Calgary Planning Commission Report (CPC2021-1414) from 2021 October 21

Planning & Development Report to
Calgary Planning Commission
2021 October 21

Development Permit in Downtown Commercial Core (Ward 8) at 526 – 4 Avenue SW, DP2020-5899

This application in the Downtown Commercial Core was submitted by S2 Architecture on behalf of the landowner, La Caille Fourth Avenue Group, on 2020 September 18. The site is within the high-density fabric of Downtown and is currently developed with a single-storey commercial plaza. As per the Applicant Submission (Attachment 5), the site's vision is for a high-density

DRAWING NO.
DP2.06

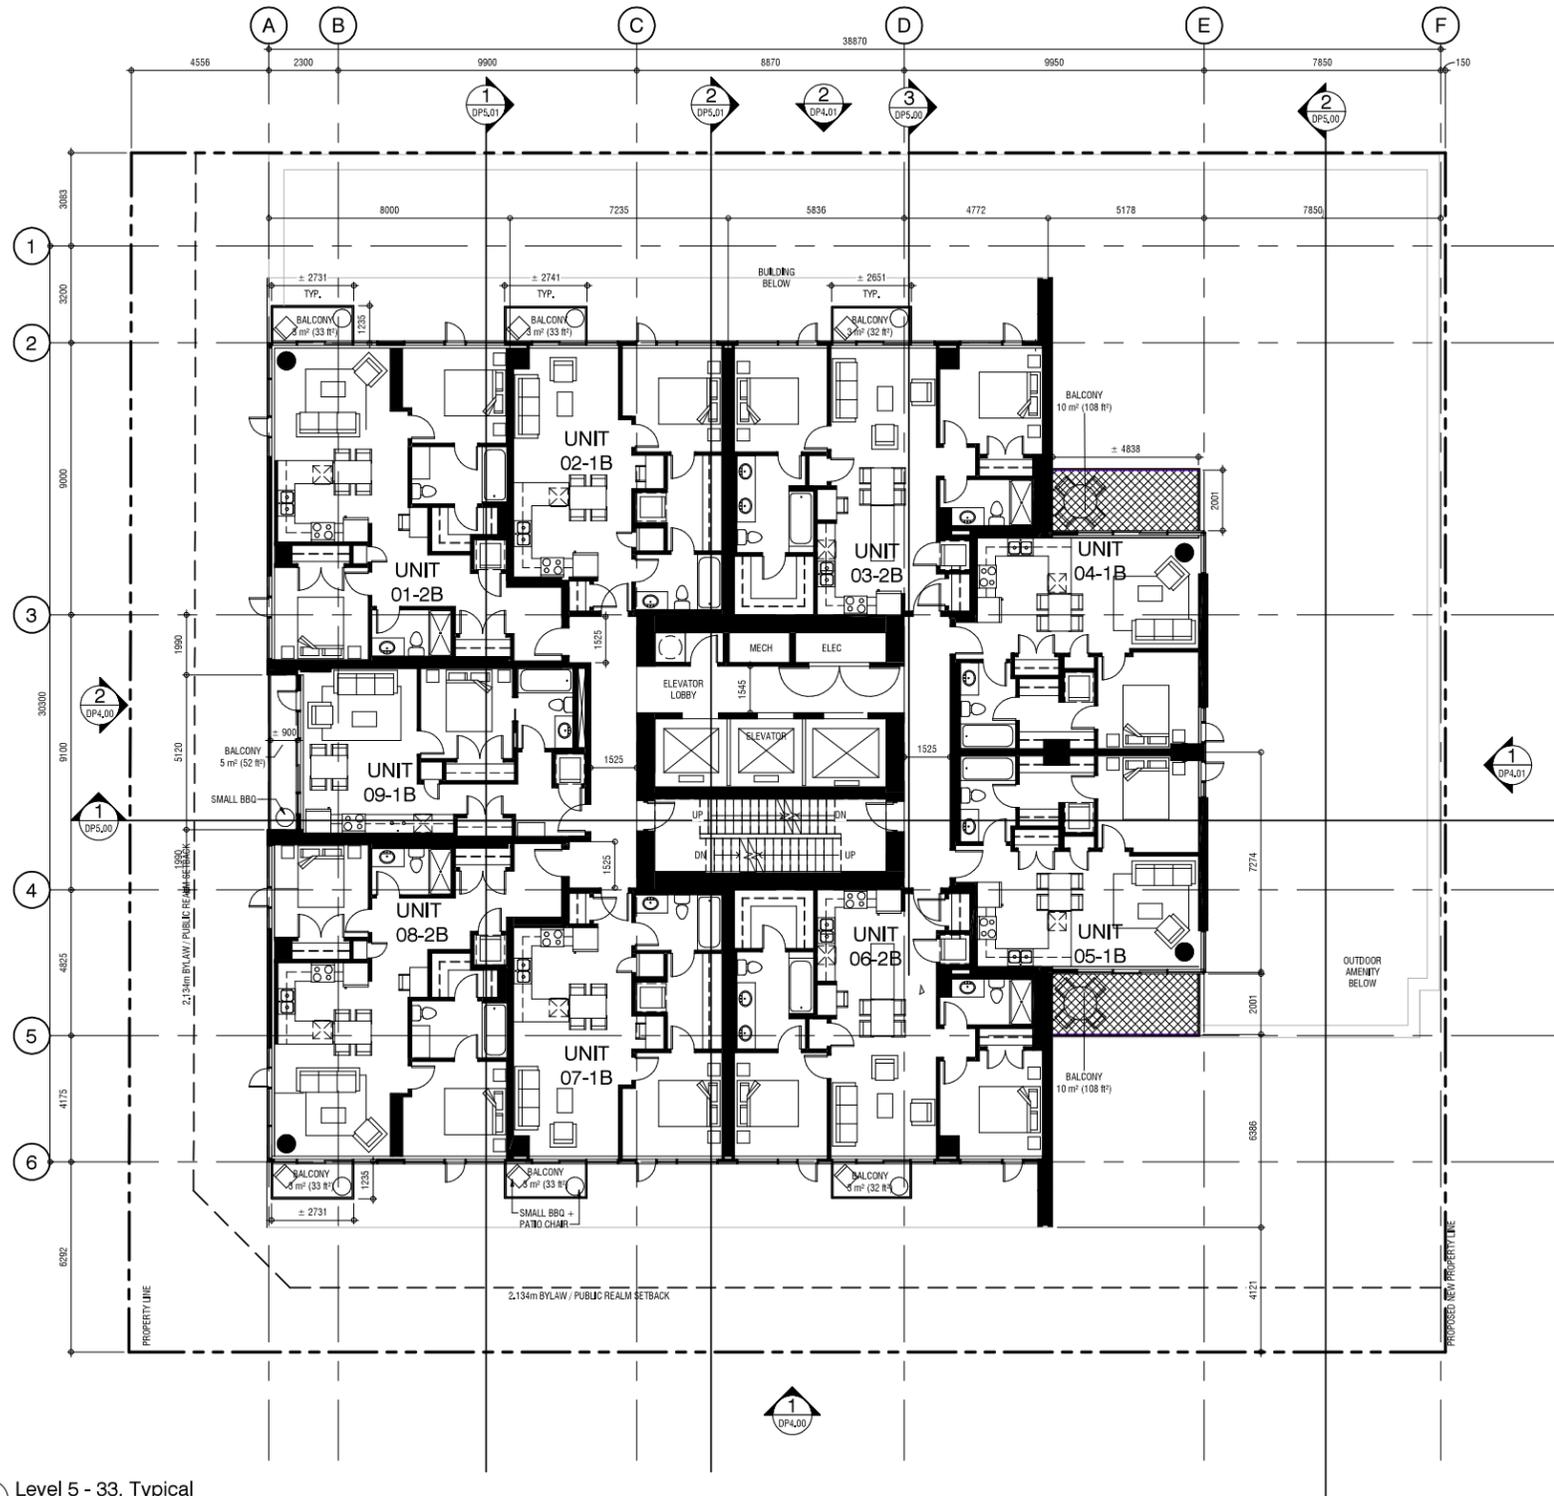
Applicant to further review the 'Outdoor Amenity' on level 3 along the northside of the building. This location presents three private patio areas immediately adjacent to a thin strip of outdoor amenity, thus creating an awkward interface with one another. Providing larger private balconies and eliminating the outdoor amenity in this area appears one solution, that may be worth exploring, to reduce potential conflict.
Applicant Response	The Design Team have reviewed the Outdoor Amenity space on level 4 (formerly level 3, per DP package). The modified design responds to comments regarding how the space is to be laid out and utilized. A trellis structure has been added directly outside the doors from the building. Under this trellis will be movable furniture and barbeques for resident use, as well as built-in planters to help define the space. There is to be a screen added which separates the Outdoor Amenity space on the east side from the units facing north. There is to be no public access to the rooftop space directly in front of the private patio areas of the units facing north. Please refer to revised DP2.06, DP-L2 and DPE1.2.

1 South Elevation
DP4.00 SCALE: 1 : 250

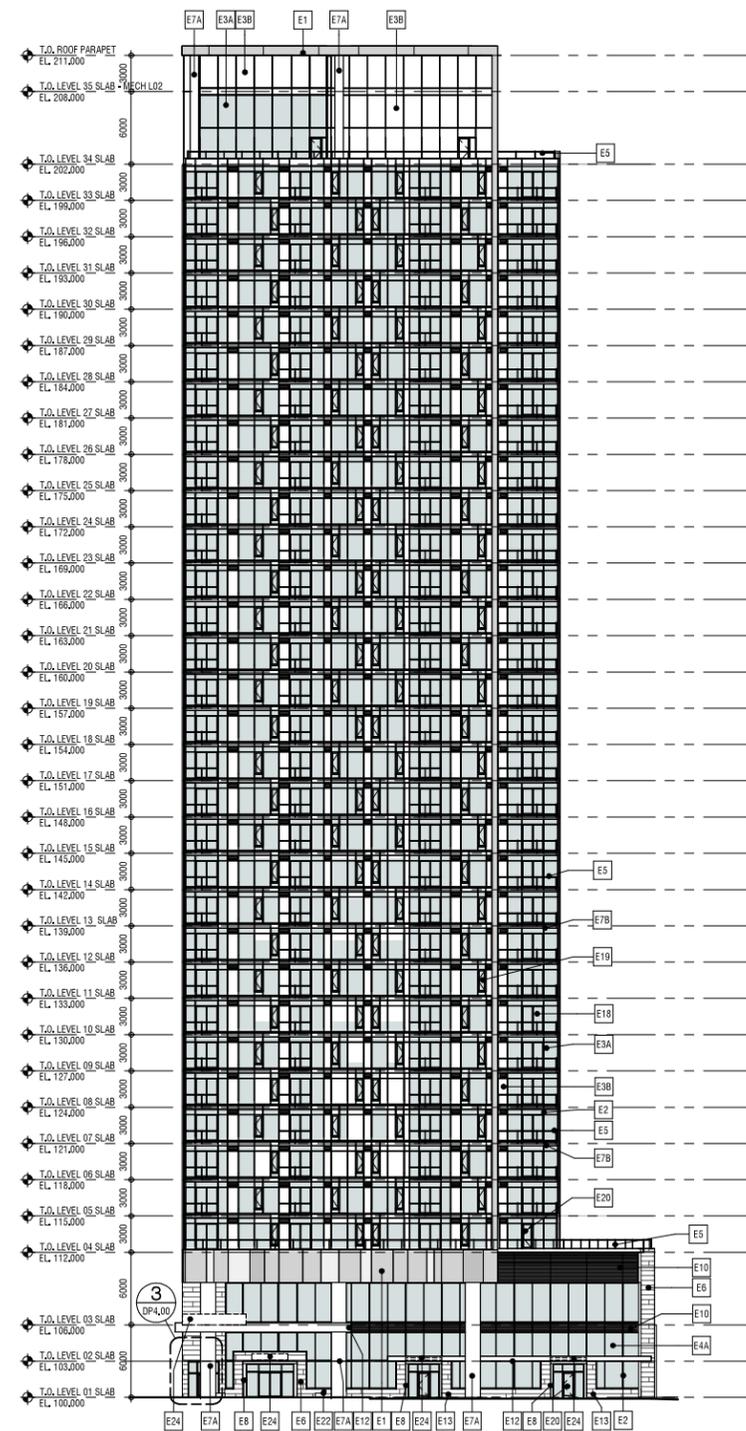
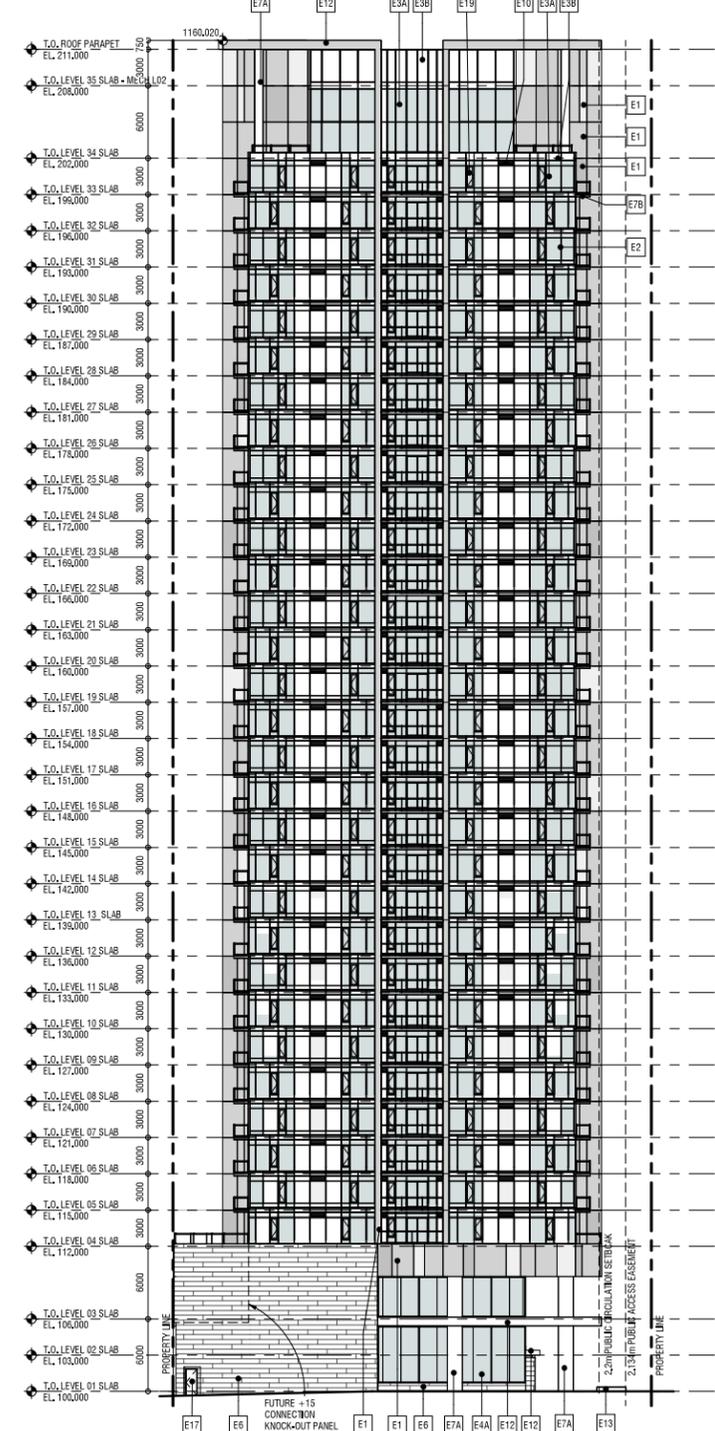
2. The south facing elevation on the corner does take advantage of the available southern exposure. The flat planes of glass at ground level and the repetitive nature of the tower elevations offer little in terms of fine-grain character. A more articulate form for the tower and a stronger architectural statement at the corner of the podium would generate a presence that would enhance the urban environment and wayfinding in this part of the core.

2. **“The south facing elevation on the corner does take advantage of the available southern exposure. The flat planes of glass at ground level and the repetitive nature of the tower elevations offer little in terms of fine-grain character. A more articulate form for the tower and a stronger architectural statement at the corner of the podium would generate a presence that would enhance the urban environment and wayfinding in this part of the core.”**

- a) The south and west facing elevations have been revisited to provide a stronger architectural statement at the corner and greater fine-grained detail has been incorporated into the podium level, addressing wayfinding aspects of the project. Please refer to revised DP4.00, DP4.01 and coloured elevations DP4.00A and DP4.01A.
- b) Two canopies have been added to the elevations on both 4th Avenue S.W. and 5th Street S.W. The first canopy is at the second level above the residential entry which projects beyond the ten-meter-high exposed exterior columns and wraps around the corner of the building to the west identifying the residential entry. This canopy will define the residential entrance and lobby from both the west and south. Thin LED lights have been added to the soffit of the canopy and are to

be extended into the building to create a strong residential entry both inside and out. The second canopy is located above the retail spaces at approximately ten feet in height and extends from the retail units east to the property line. This canopy projects off the building four feet and will have feature lights in the soffit to give a human scale to the outdoor patio areas. Having the two canopies at different heights introduces a more human scale to the façade and creates a differentiation between the residential and retail uses along the 4th Avenue SW frontage. Please refer to revised DP4.00 and DP4.00A.

- c) The base of the building has been increased in height to +/-700 mm (2.3 ft) to allow for a durable material and ground the building, the material is to be the same material as is represented on the east and west podium level. By increasing the height of the base this will address any potential maintenance issues around the base. Please refer to revised DP4.00 and DP4.00A.

- d) The entrance to the residential use at the corner has now incorporated an arch below the lower canopy with the underside of the arch at ten feet in height which allows the opportunity to add both surface mounted entry lights on either side of the entry and the project name and address above the doors, this arch is to be the same material as the base. At each of the retail entrances there have been columns introduced on either side of the entry doors to highlight where the respective entrances are, the materials on the columns are to be the same as the base. Please refer to revised DP4.00 and DP4.00A.

1 East Elevation
DP4.01 SCALE: 1 : 250

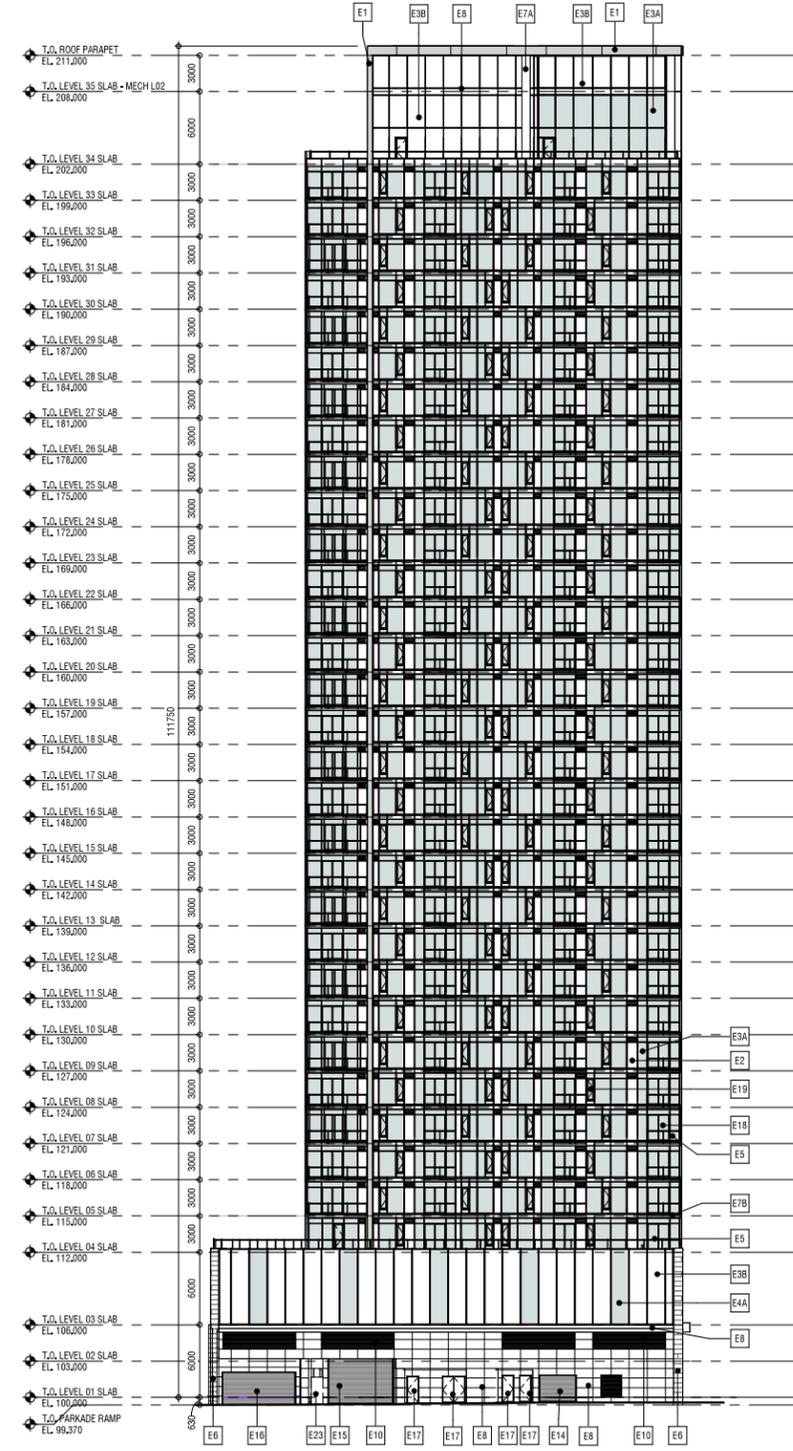
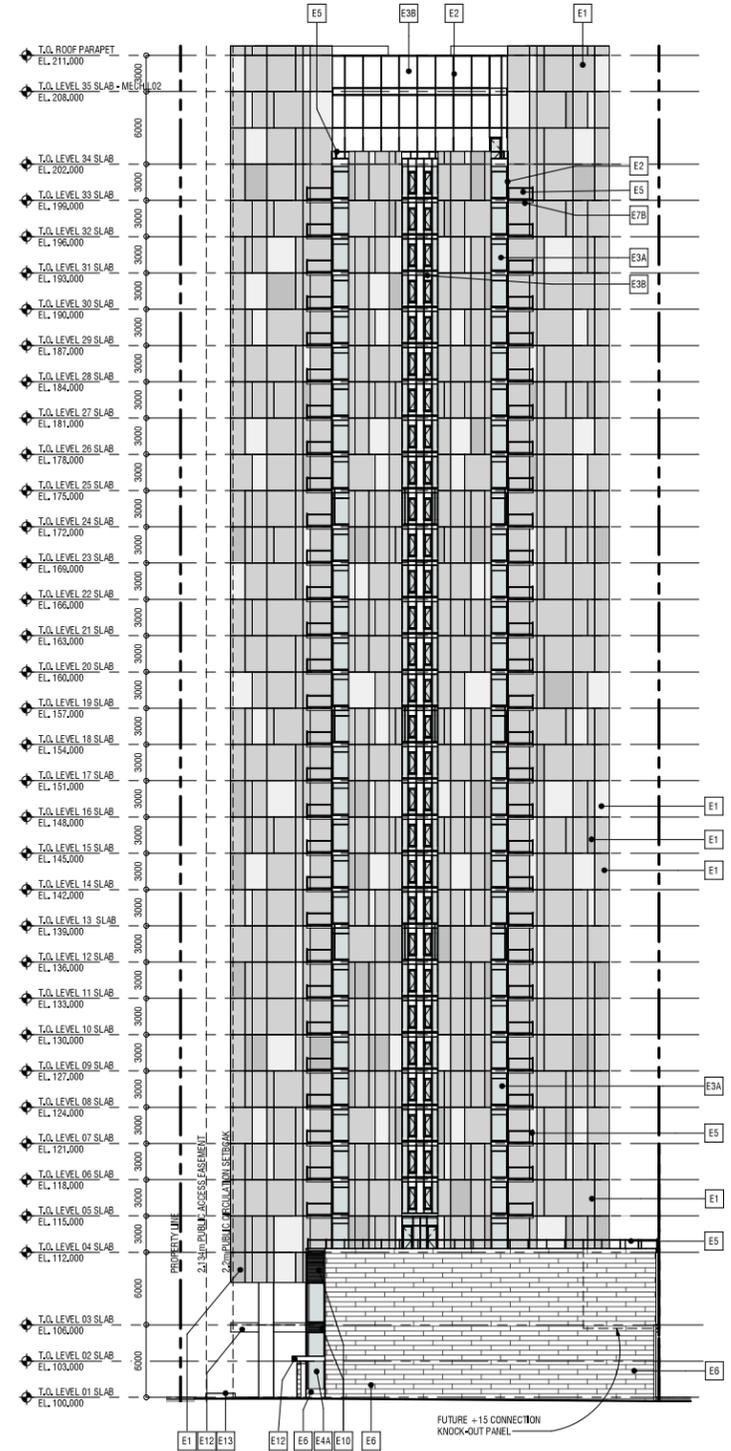
- identify ways that commercial/retail can be added along 5 Street SW;
- identify ways to consolidate the bike parking on level one or P1 of the parkade; and
- To explore ways to reduce spandrel or add glazing to east elevation;

- e) The tower has been purposefully designed to keep the simplicity of the tower form. The main feature of the tower are the walls on the east side which are a patterned composite panel system which will add textural character to the building and this treatment is continued from the top of the podium to the roof to tie the podium to the tower element above and will act to also screen the mechanical equipment of the roof. Please refer to revised DP4.01 and DP4.01A.
